Re: March 31, 2011 HDR Letter Approval
City of Greensboro, White Street Landfill
Phase III – Permit 41-12 Renewal
Guilford County, Permit No. 41-12

Re: Response to your March 15, 2011 email Comments
City of Greensboro, White Street Landfill – Phase III Permit 41-12 Renewal
Guilford County, Permit No. 41-12

WHITE STREET LANDFILL
PERMIT 41-12
PHASE III
PERMIT AMENDMENT

CELLS 1, 2, AND 3
DEVELOPMENT PLAN
(4H:1V TO 8% AT 910')

SHEET
FIGURE 5-3

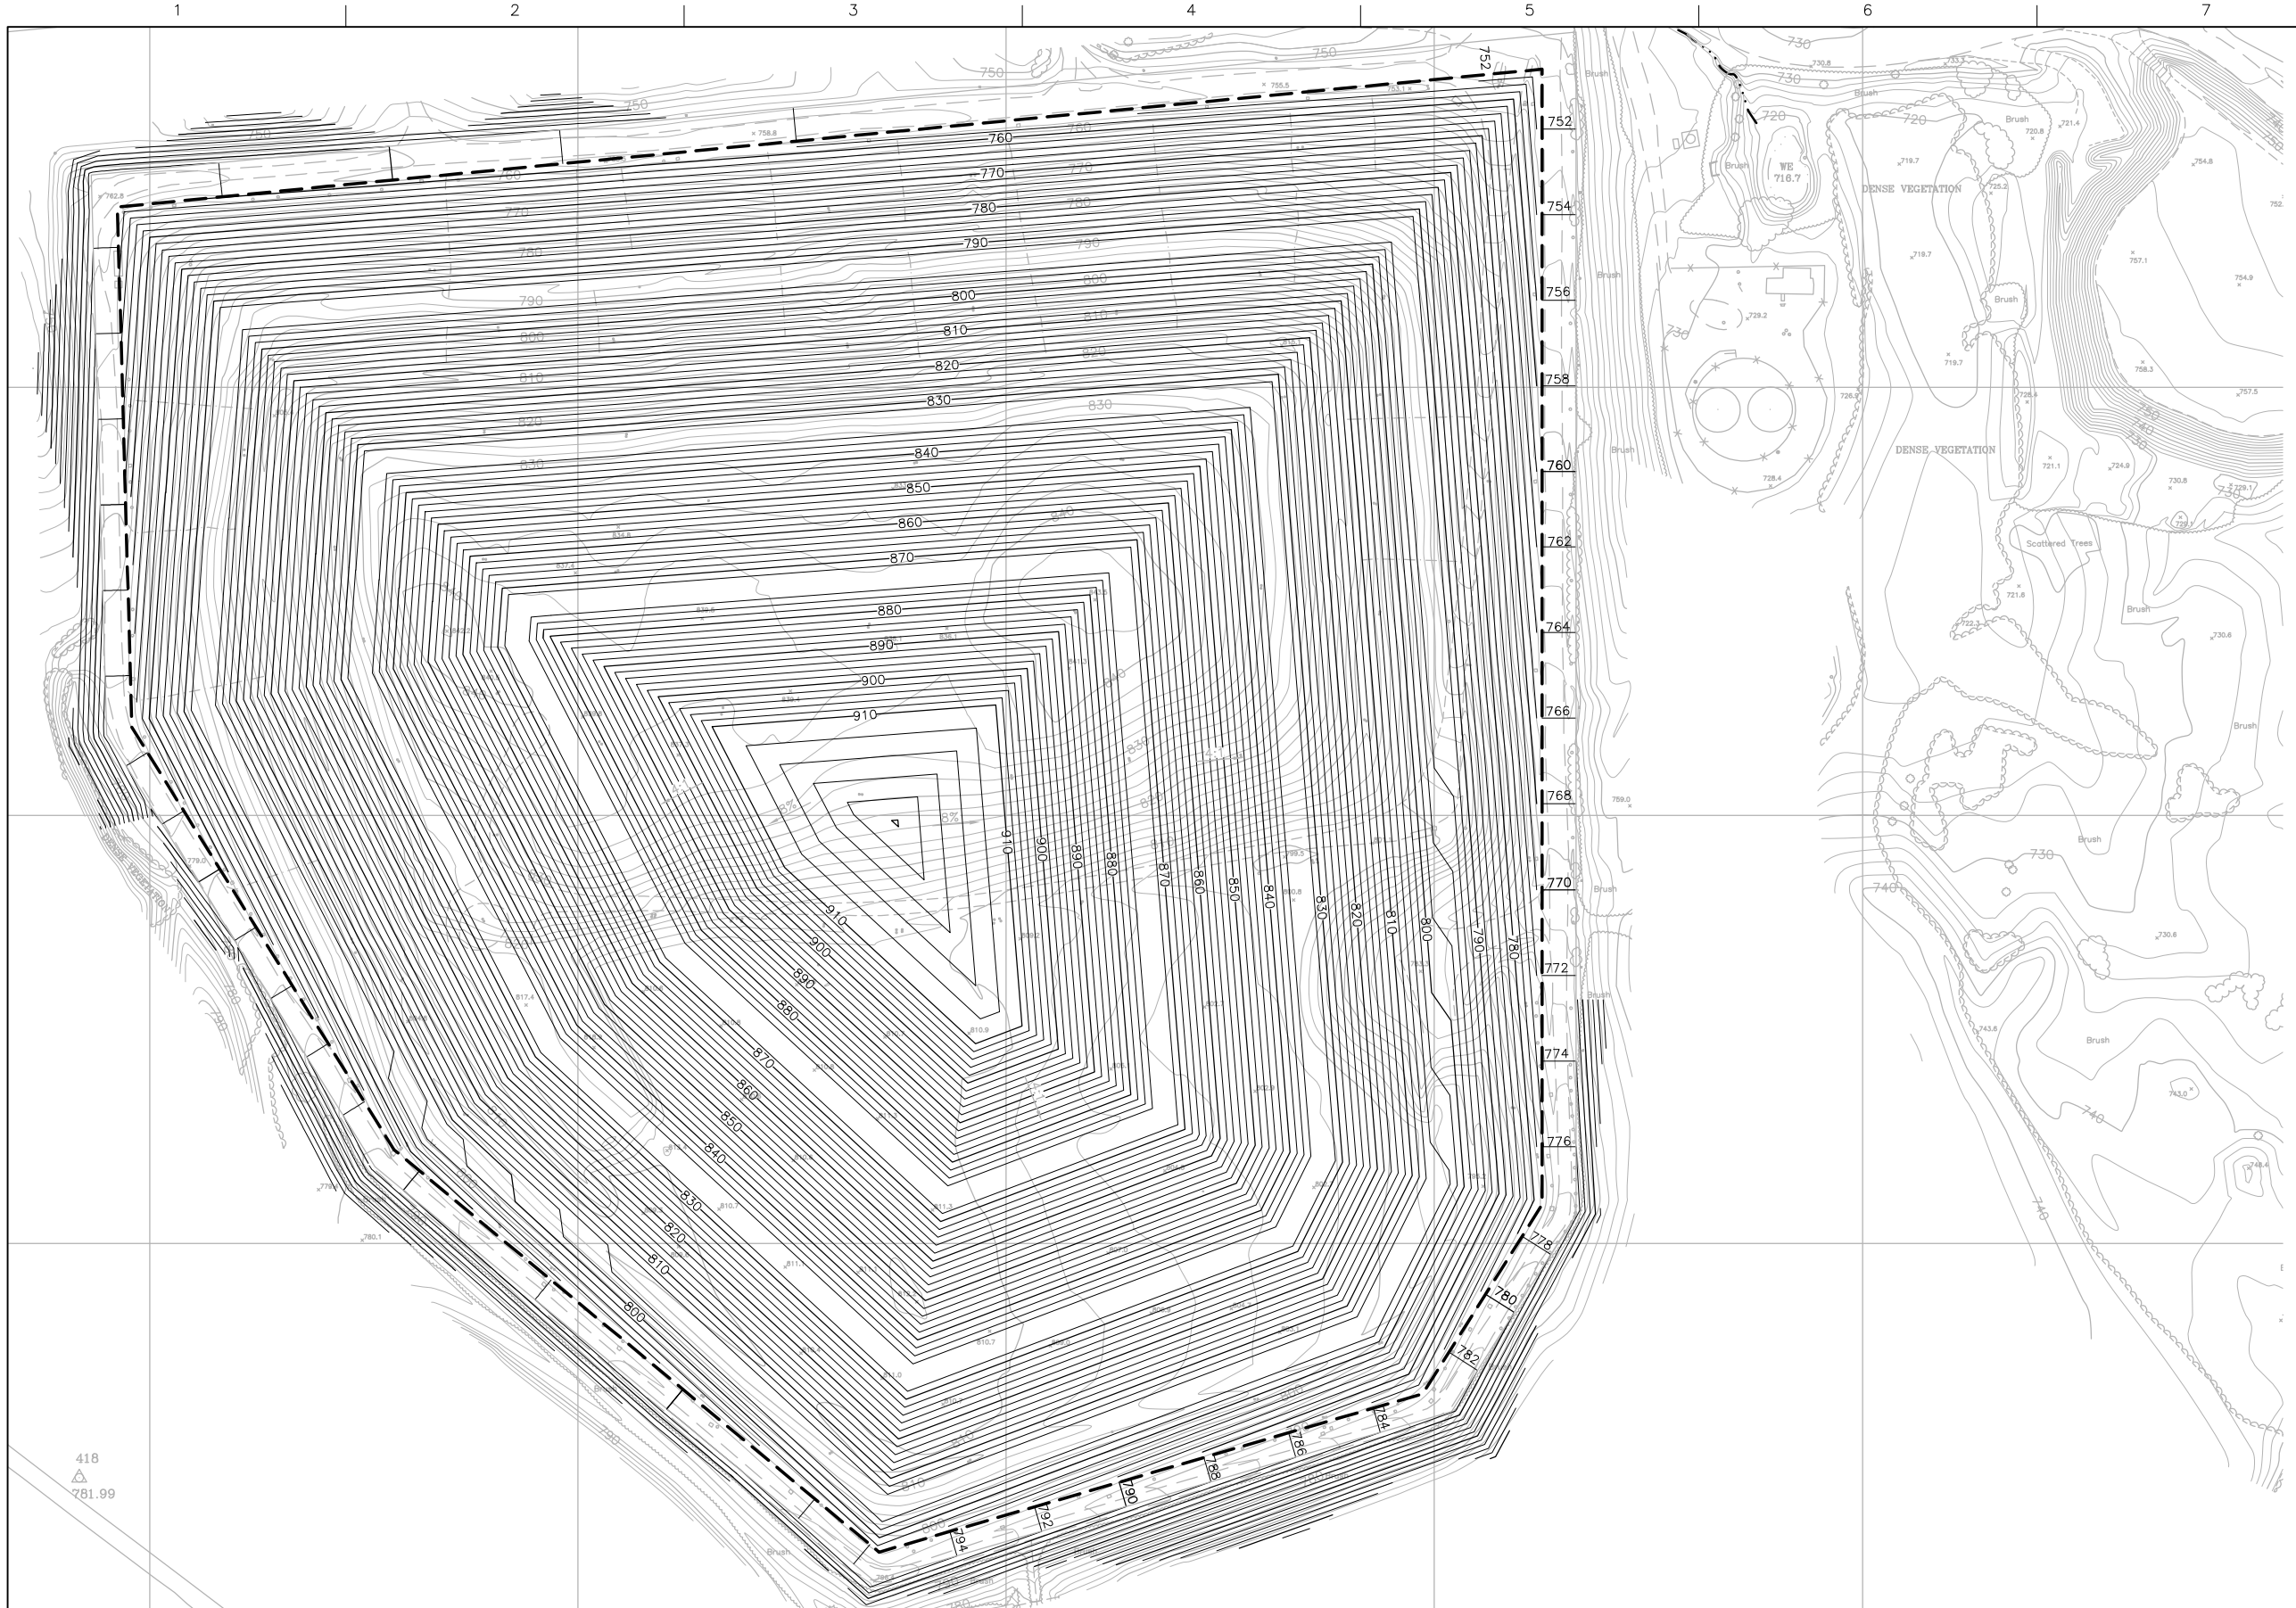
I want to have the explanation of the capacity in a letter or email that I can reference in the permit. That is important.

There is confusion on what the permitted capacity is for Phase III. The 2005 NCDENR permit did not reflect the changes in the 2000 permit modification. Here is a brief history on the capacity numbers referenced for Phase III (Permit 41-12).

The NCDENR 2005 Permit references the 3,885,000 cy for waste only which is not how we measure consumed airspace. Typically we look at operating airspace which includes waste, daily and intermediate cover. Based on our calculations we suggest either referencing the Total Gross Capacity of 5,352,000 cy or the Total Operating Capacity of 5,058,000 cy. Figure 5-3 has been revised to include the Total Gross Capacity of 5,352,000 cy and has been enclosed with this letter.
